Subject: MHI's Response to US-APWR DCD RAI No. 839-6130 Revision 3 (SRP 06.02.02)

Response to Request for Additional Information No. 839-6130
Revision 3

US-APWR Design Certification

RAI NO.:	**NO. 839-6103 REVISION 3**
SRP SECTION:	**06.02.02 – Containment Heat Removal System**
APPLICATION SECTION:	**6.2**
DATE OF RAI ISSUE:	**10/14/2011**

Figure 2: Water Volume Inside Openings on 2nd Floor

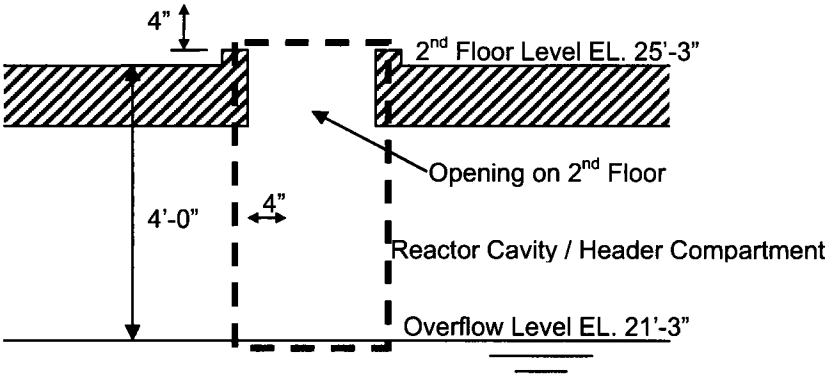
In addition, request MHI clarify if water in transition from the 25' 3" elevation through the ten, 18 inch transfer pipes to the RWSP minimum water level elevation (~ 4 foot elevation) was accounted for in the calculation of "Return Water on the way to the RWSP" (MUAP-08001 Table 3-10)? If this water in transition was not accounted for, provide an update to Table 3-10 and explain how this volume of water impacts the margin depicted in MUAP-08001-P (R5) Figure 3-11?

The height of water overflowing the weirs around the floor openings is 4 in. as the water enters the opening. The water thickness along the inside of the opening will be greater at the top of the opening due to gravity and will decrease with the falling height because the flow rate is constant. Therefore, a water thickness of 4 in. is conservatively assumed to exist from the 2nd floor to the lower floor as indicated by red dash line in Figure 2.

The sum of the perimeters of the openings on the 2nd floor is about 100 ft (See Figure 1). So the water volume flowing through the openings is 134 ft^3.
The water volume is account in the "Volume of water in piping and floor opening on 2nd floor" of Attachment 1 of RAI answer to question No. 06.02.02-70.
